Construction Change Directive

PROJECT: *(name and address)*
Highland Township Fire Station 2
PIA #18-122B

CCD INFORMATION:
Directive Number: 001
Date: July 13, 2021

“EXHIBIT A” – CCD NO. 1

WARDLOW ROAD STORM SEWER PROFILE
SCALE: 1"=30' HORIZONTAL
1"=3' VERTICAL

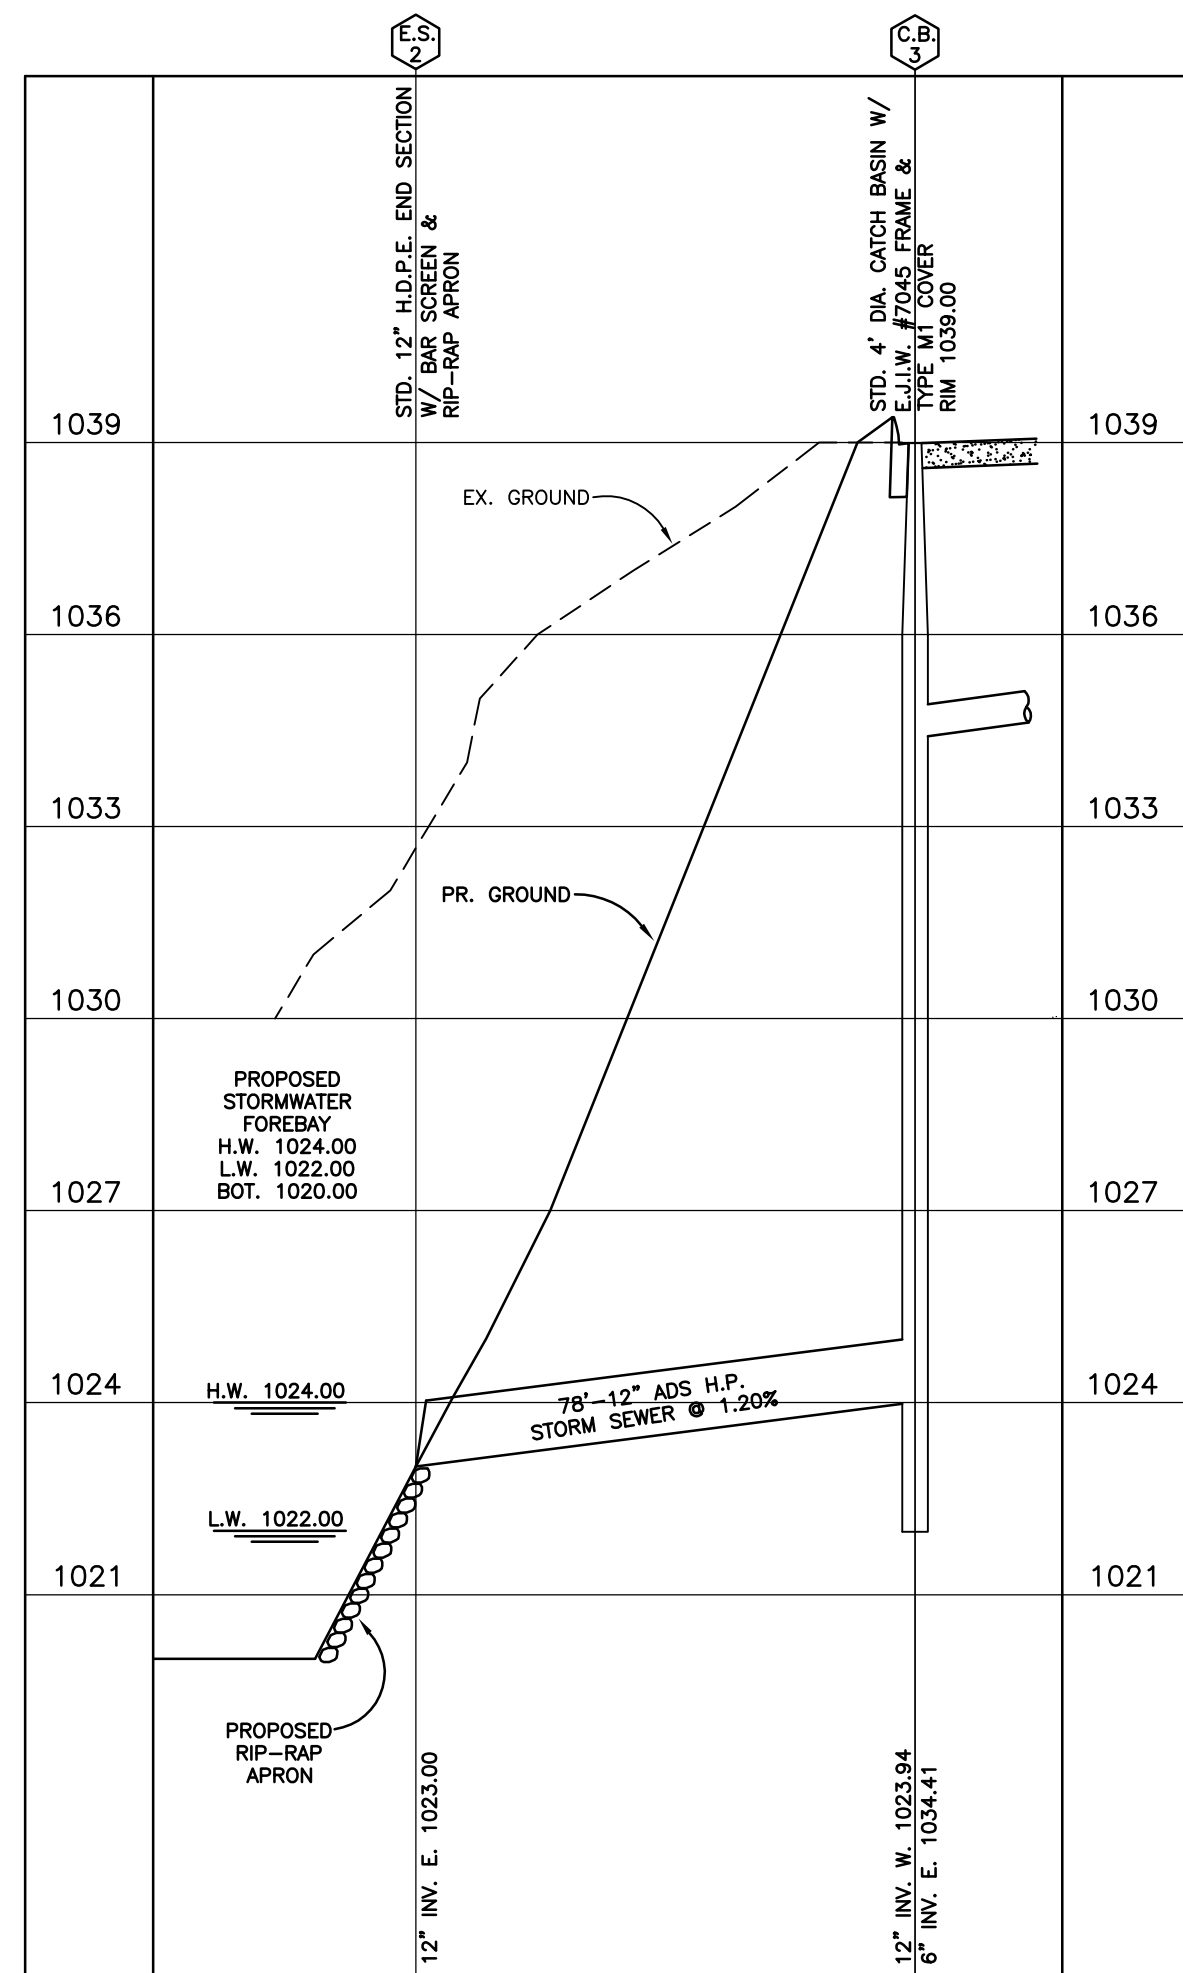
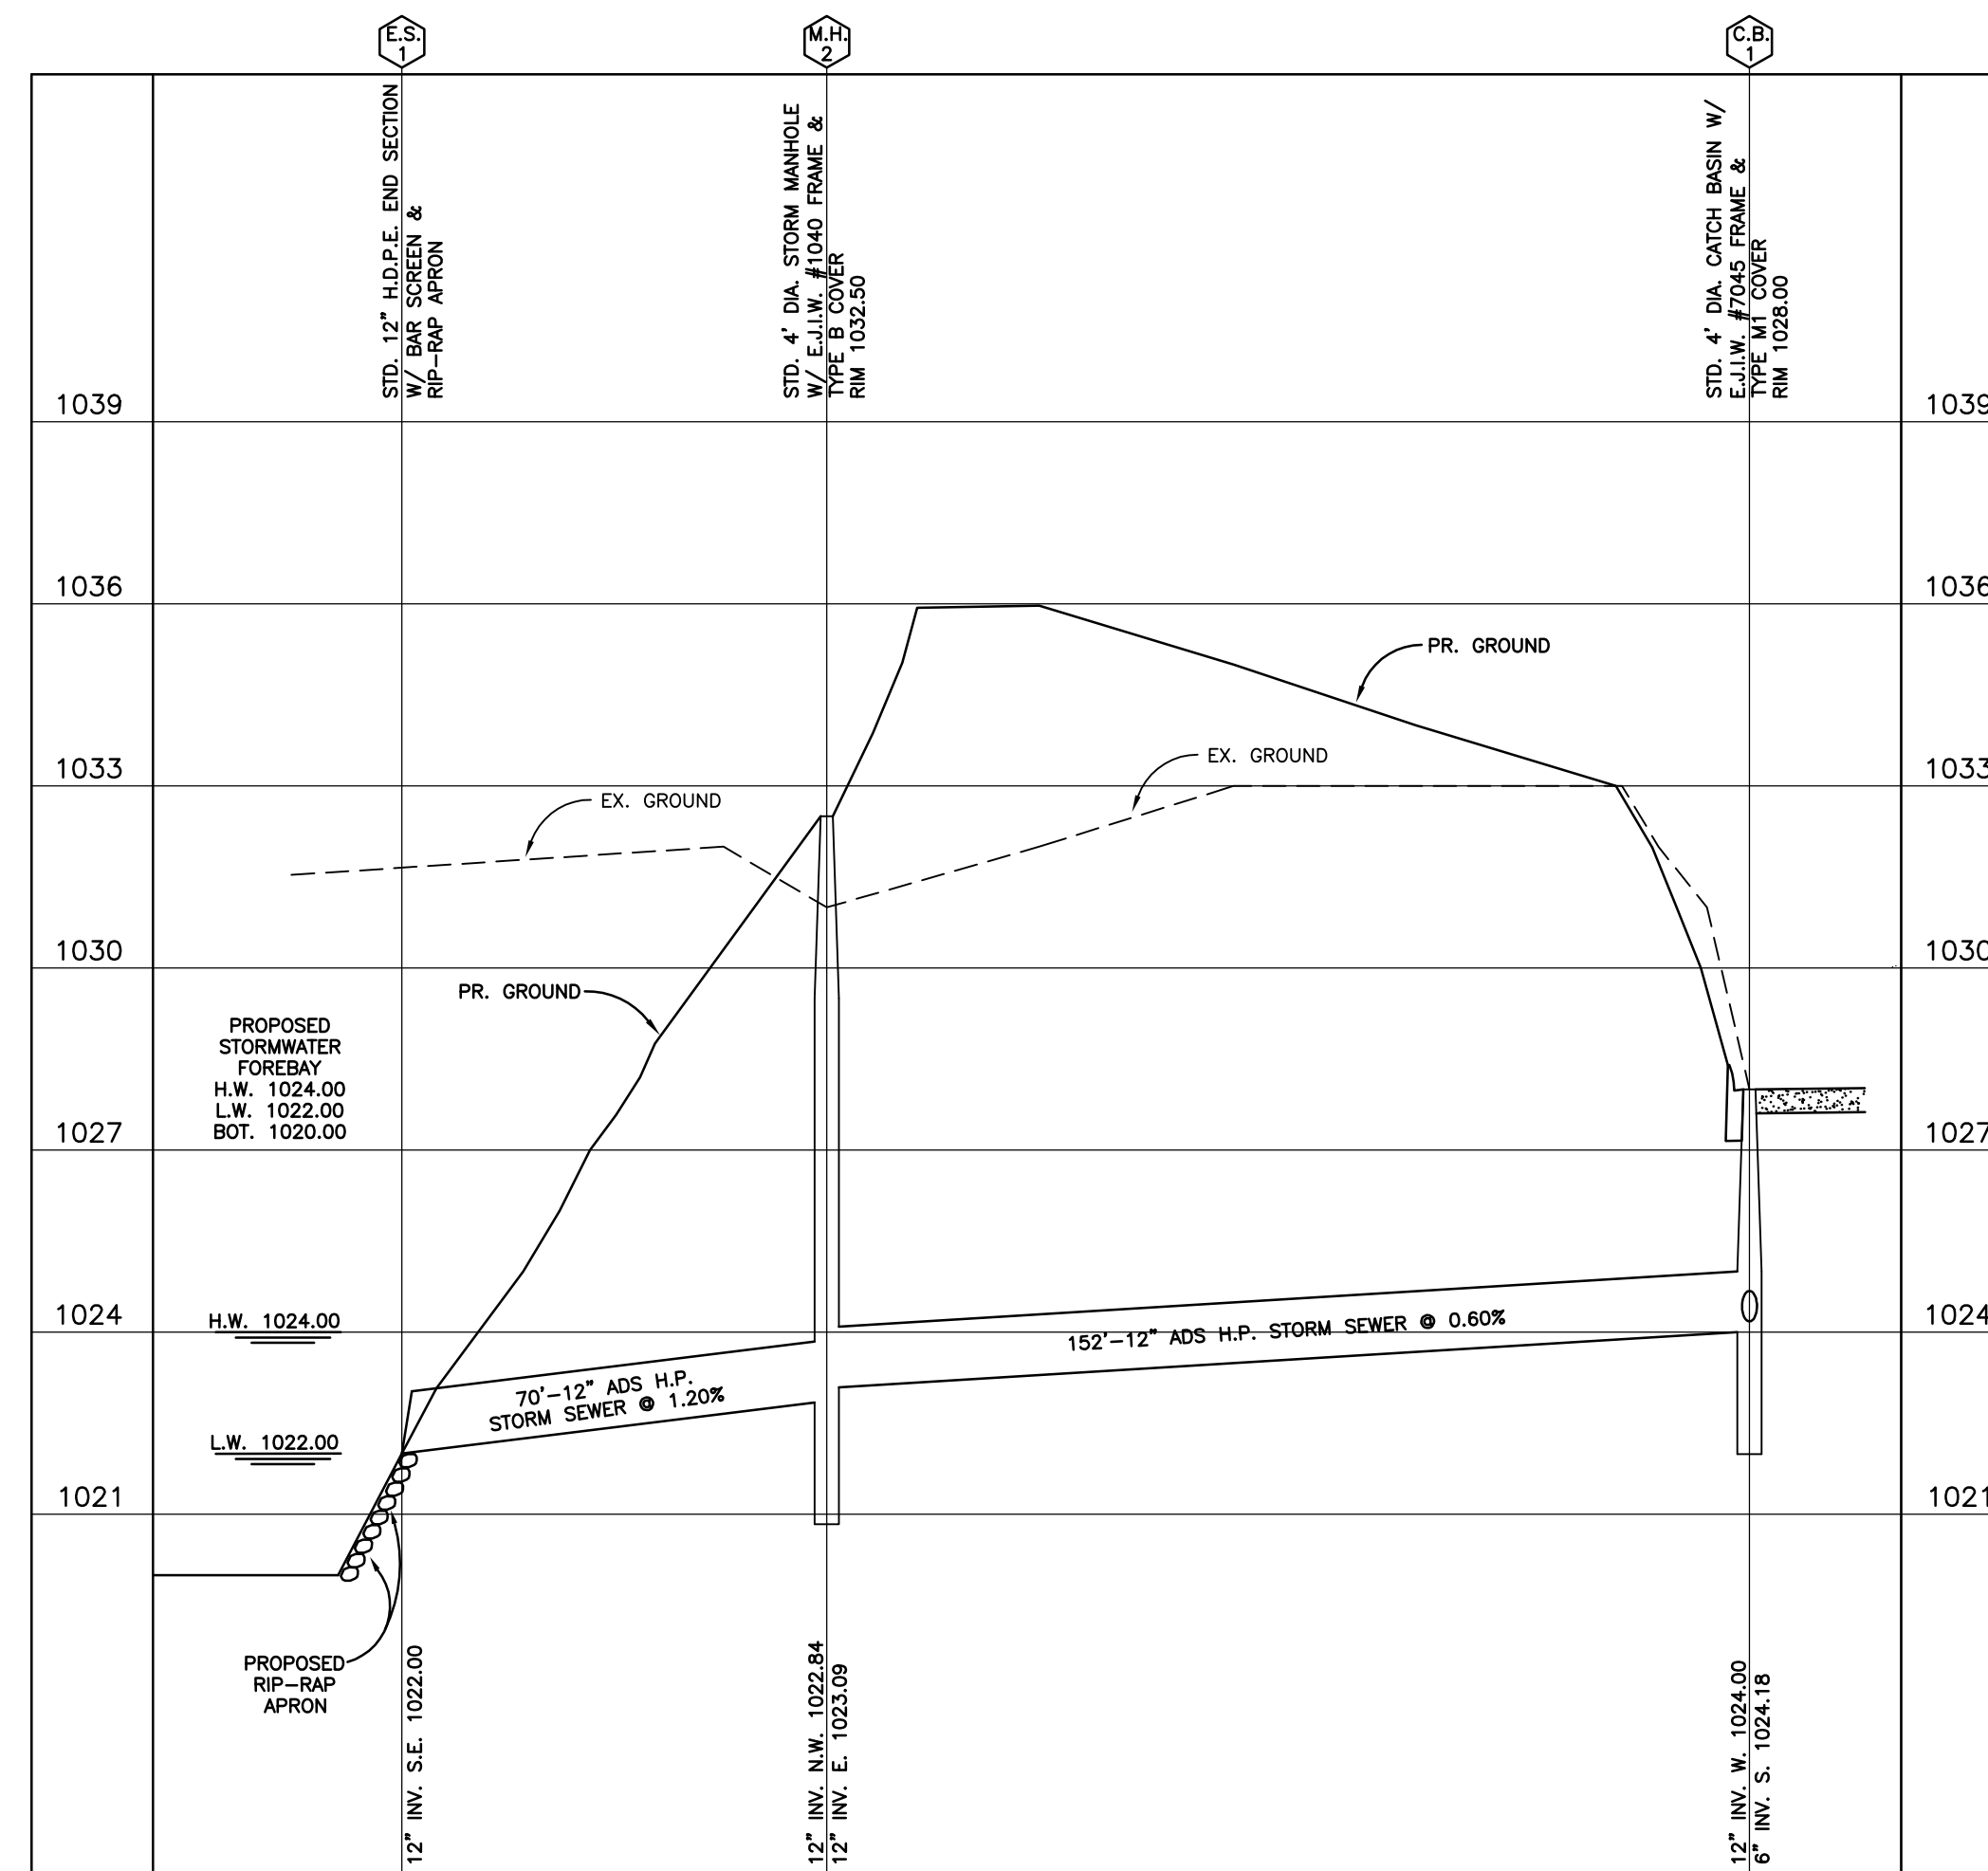
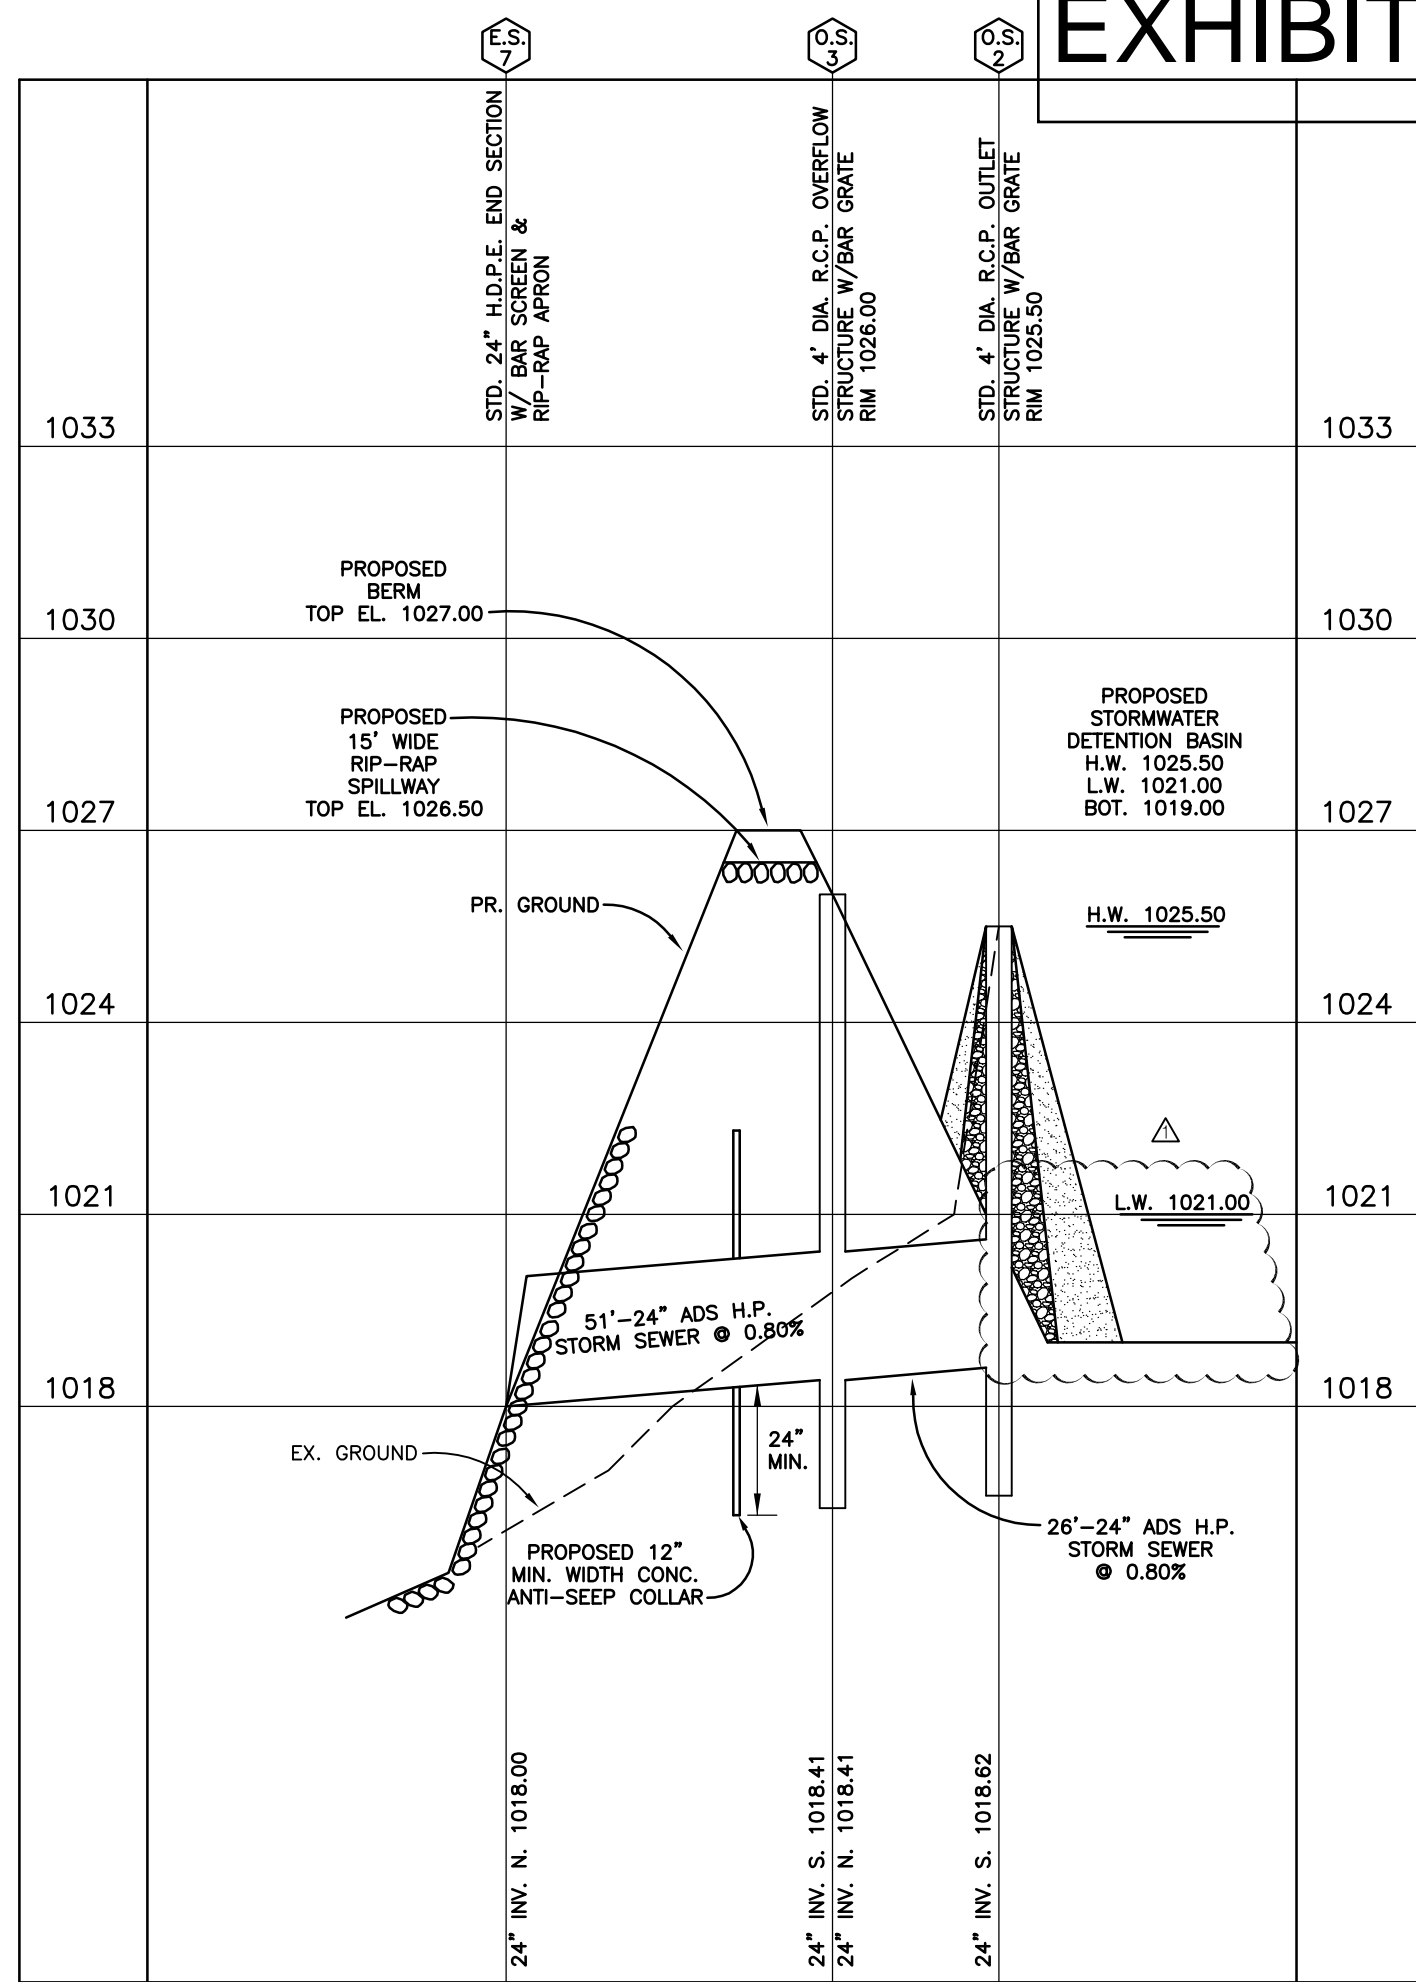
- A. Added 2' deep sediment sump in Stormwater Detention Basin.
